## **ADDENDUM NO. 3**

### **SMITHS FALLS HYDROELECTRIC PROJECT**

**Stowe Electric Department  
Stowe, Vermont**

**Addendum No. 3 Issued January 30, 2026**

**ADDENDUM 3 - ATTACHMENT A**  
**OBERMEYER 1-LINE SCHEMATIC**

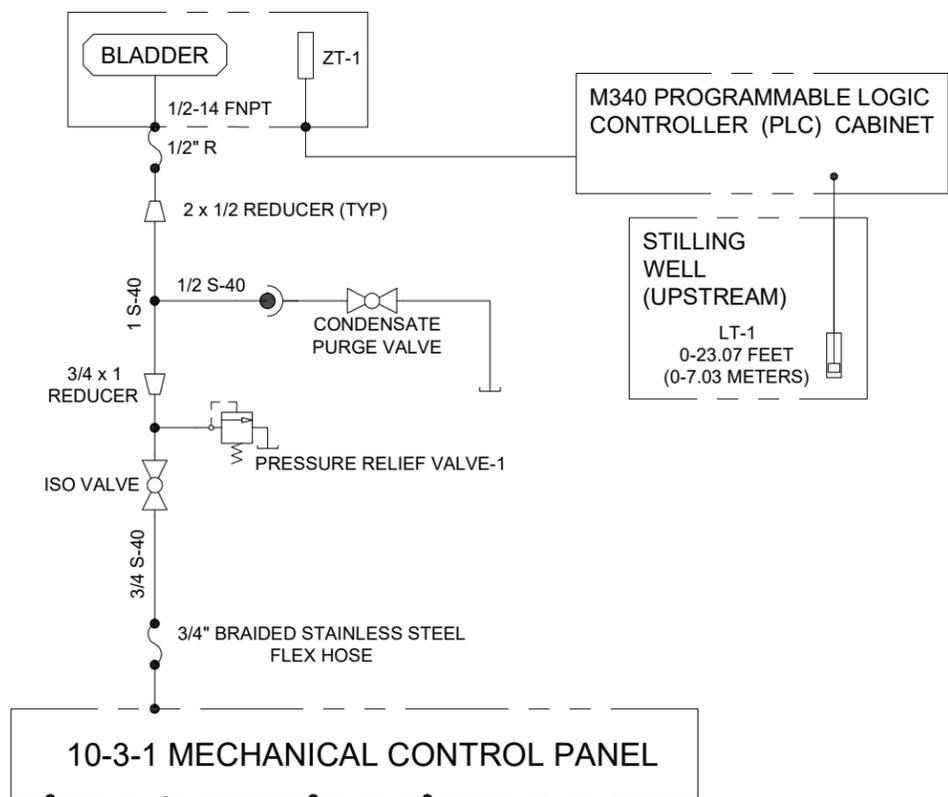
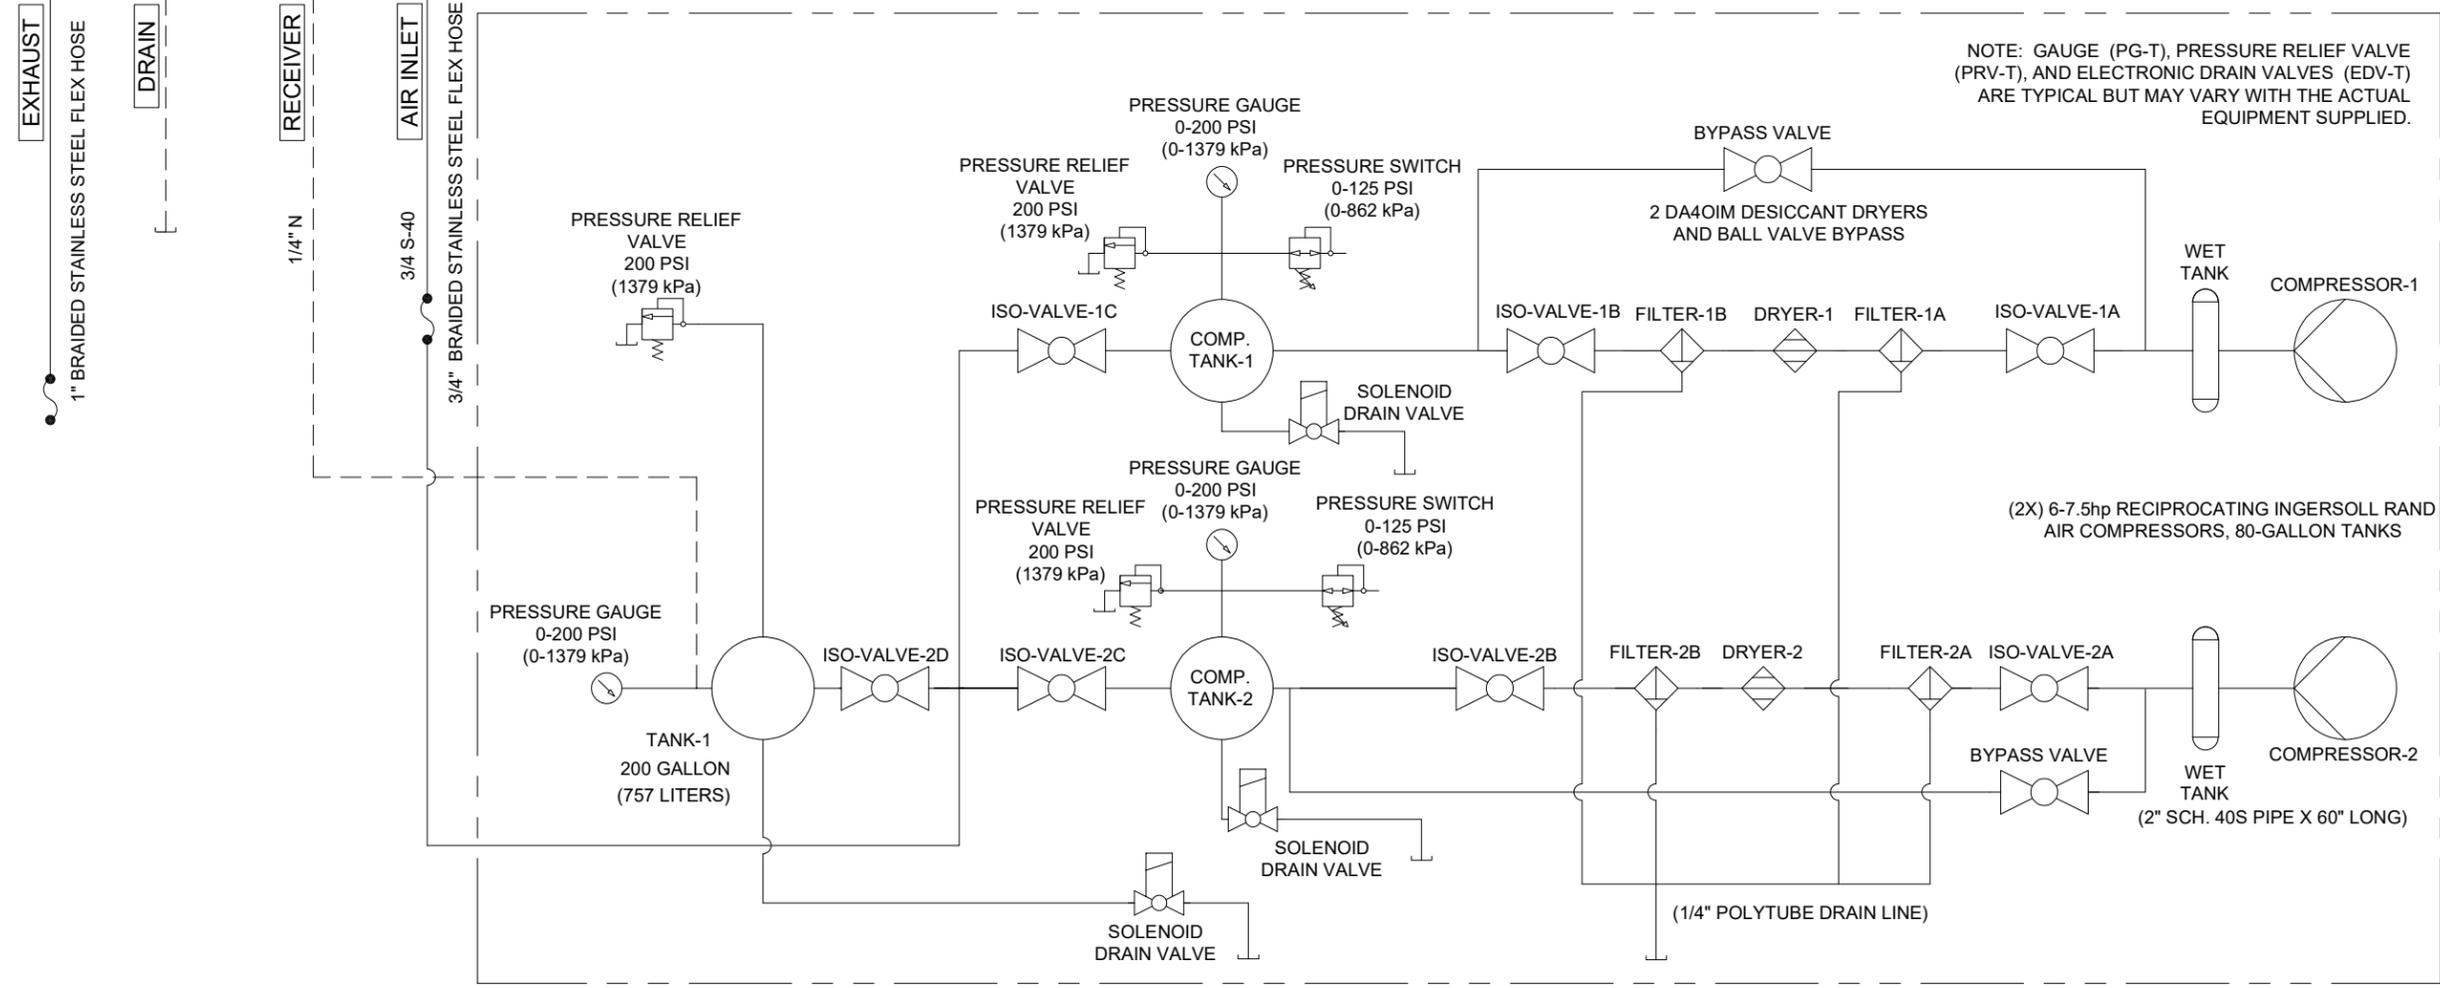
- 
- d. Please provide details for the construction of the lockbox.
  - e. The layout for the PLC, ACP, dual compressors and the air tank is shown on STR-03. Per specification 35 22 13:

**Please provide a one-line drawing and piping schematic for the interconnect work associated with this equipment.**

- e. Refer to Attachment A for a one-line schematic.
- Q2: **Please note drawings STR-03, A1.0, A2.0, A2.1, M1 and M2 and advise on the following:**
- a. Please confirm that the ceiling height is 8'-8 -1/4" above the concrete slab as shown in section 2/A2.1.

**ADDENDUM 3 - ATTACHMENT B**

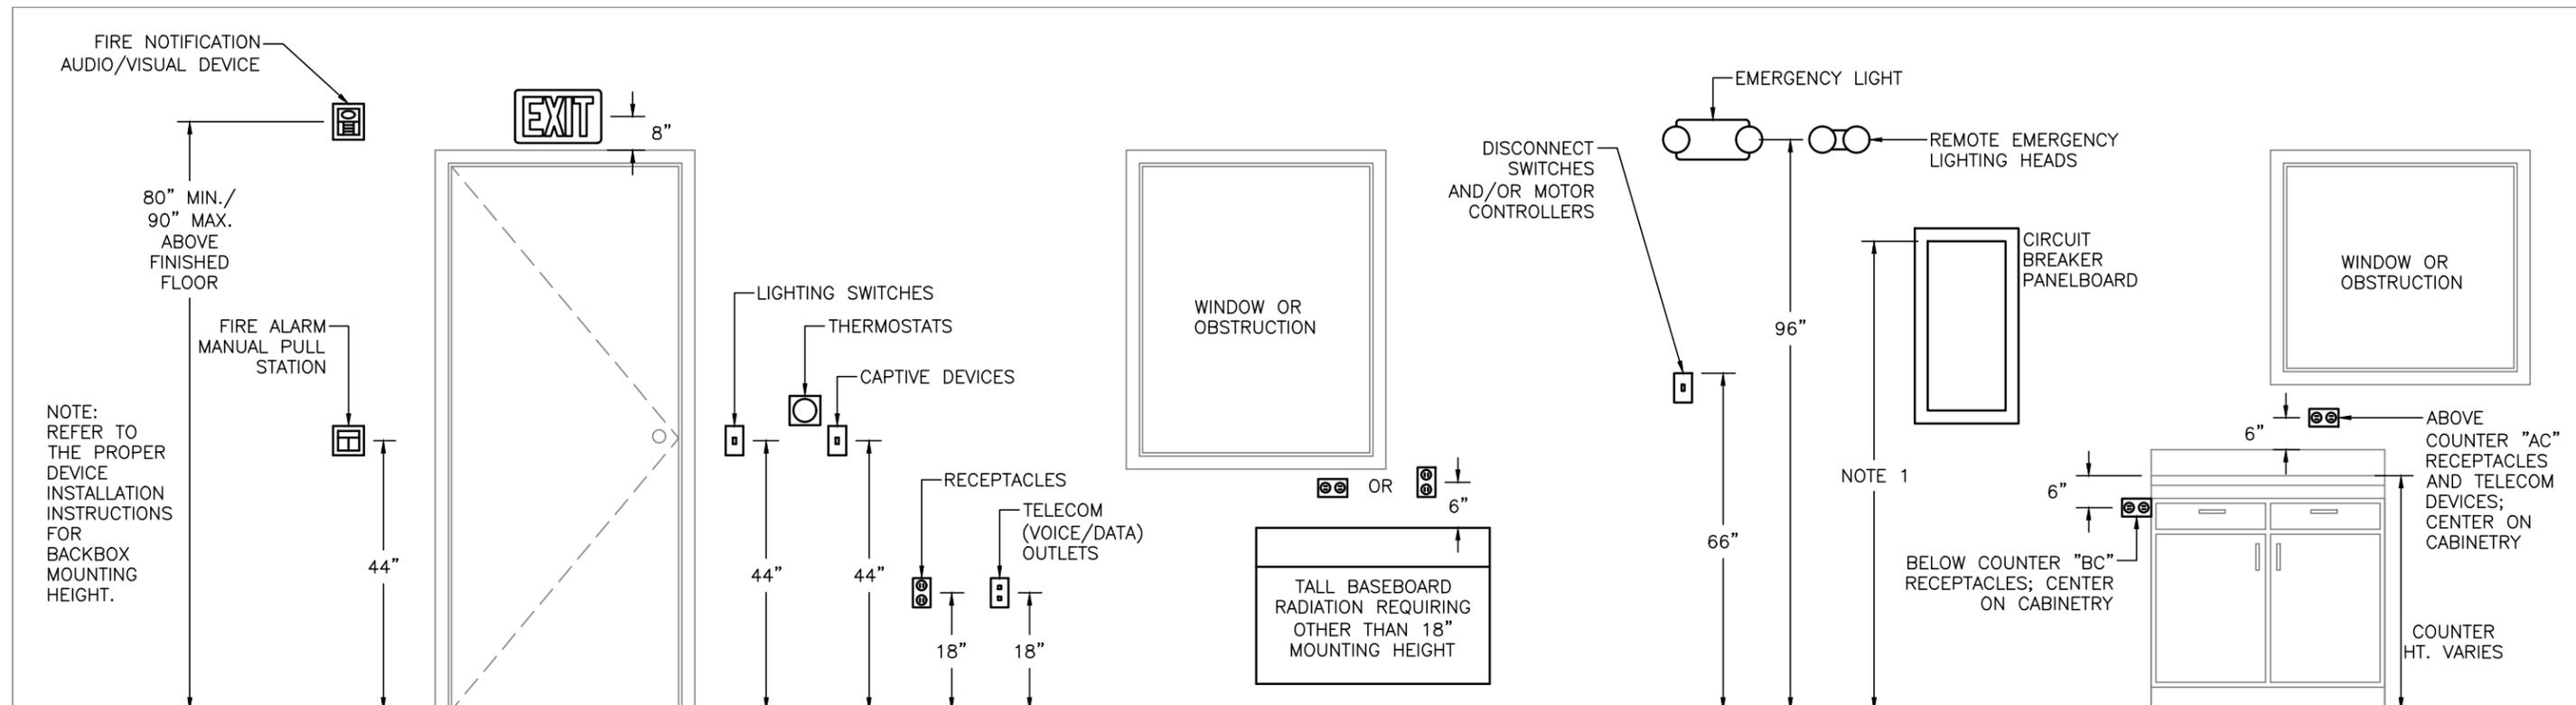
- j. **Please confirm that the location of the Hydro Generator Service Disconnect Shown on E2 is accurate. Additionally, please provide mounting heights and requirements, as well as trim details.**
- k. **Per drawing note 3 on E2, add provide the mounting location, height, requirements as well as trim details.**

k. Refer to Attachment B for additional information related to mounting heights.
